<b>Docket Number:</b>	07-AFC-06C
<b>Project Title:</b>	Carlsbad Energy Center - Compliance
<b>TN #:</b>	203546
<b>Document Title:</b>	Response to Project Owners Supplemental Response to Data Request Set 3 (TN 203512)
<b>Description:</b>	letter
<b>Filer:</b>	Arnold Roe, Ph.D.
<b>Organization:</b>	Power of Vision
<b>Submitter Role:</b>	Intervenor
<b>Submission Date:</b>	1/21/2015 1:46:00 PM
<b>Docketed Date:</b>	1/21/2015

Via E Filing  
January 16, 2014  
Carlsbad Energy Center Project (07-AFC-06C)

## **Response to Project Owners Supplemental Response to Data Request Set 3 (TN 203512)**

**POWER OF VISION**  
**POV Figure VIS-1**  
**Transmission Tie Line Relocated**  
**To West Side of The Pit**  
**January 21, 2015**

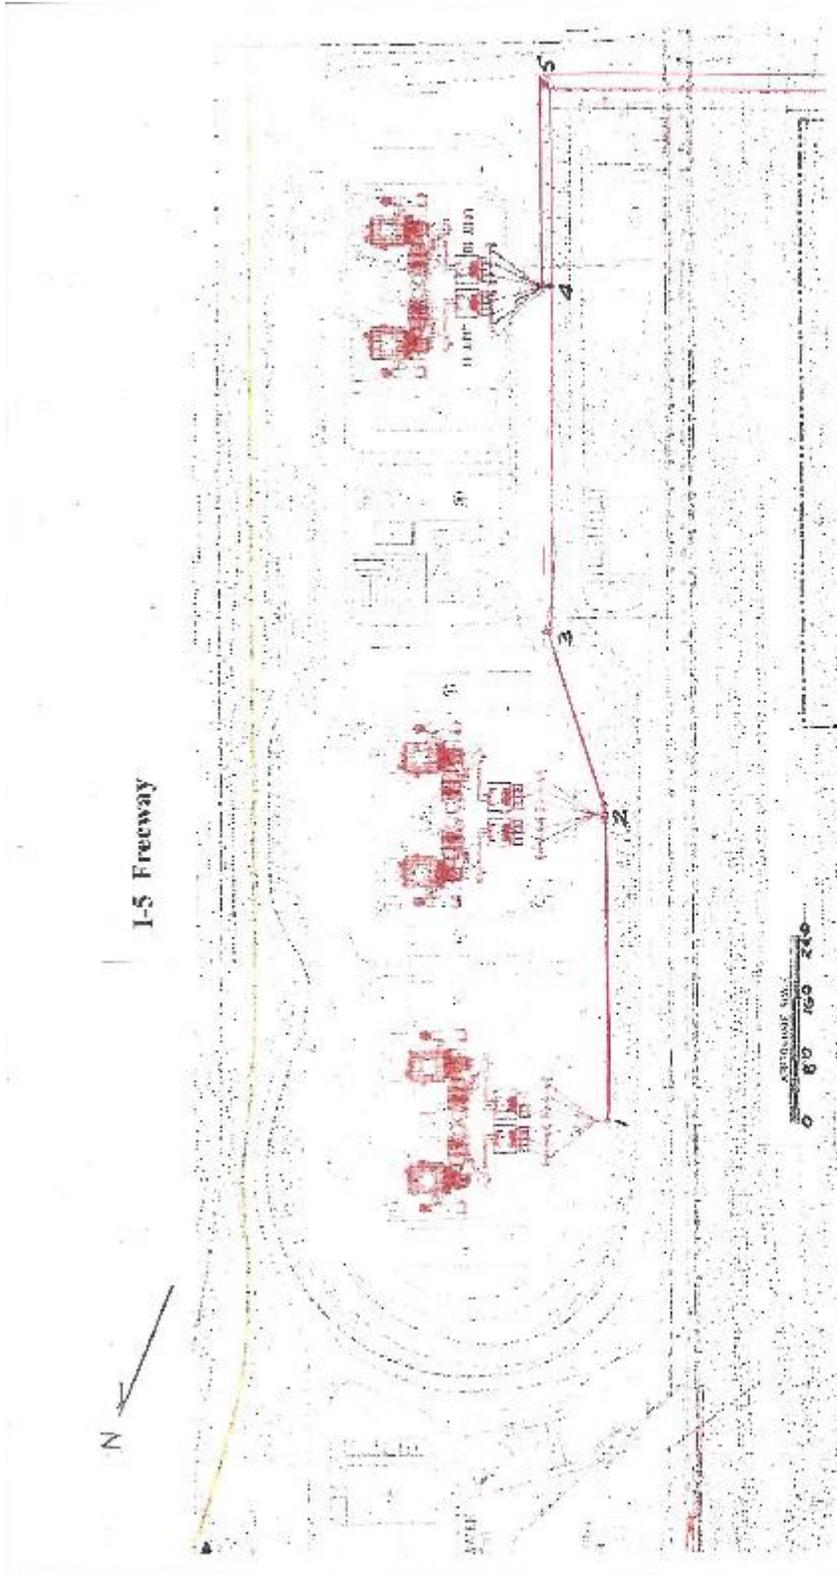
At the workshop, we also pointed out to the Project Owner that careful thought had not been given to their addition of another pole in the pit since, since with the existing 98' height of the poles, the lowest conductor crossing over the upper rim road would be approximately 36' (60' from base of pole to lowest conductor, less worst case of 6' conductor sag, less 18' from base of pole to upper rim road), well above the GO-95 required minimum clearance of 30'.

More importantly, at the workshop, the Project Owner balked at discussing any one of the numerous alternative locations for the transmission tie line that we have been recommended to them since April, 2014. Amongst these alternatives are: a) direct burial; b) eliminating the poles completely by using the H-frames to carry the lines within the pit area; c) rotating each pair of units 180 degrees around a point midway between the smoke stacks (to avoid re-doing the airmod calculations) so that the poles are on the Western edge of the pit (see attached POV Figure VIS-1); and lastly and least desirable, d) lowering all of the poles into the Eastern edge of the pit.

- Poles 1, 2, & 3 located at the bottom of the pit.
- Pole 4 can be located either at the bottom of the pit or west of the upper rim road.
- Pole 5 located adjacent to pit access road.
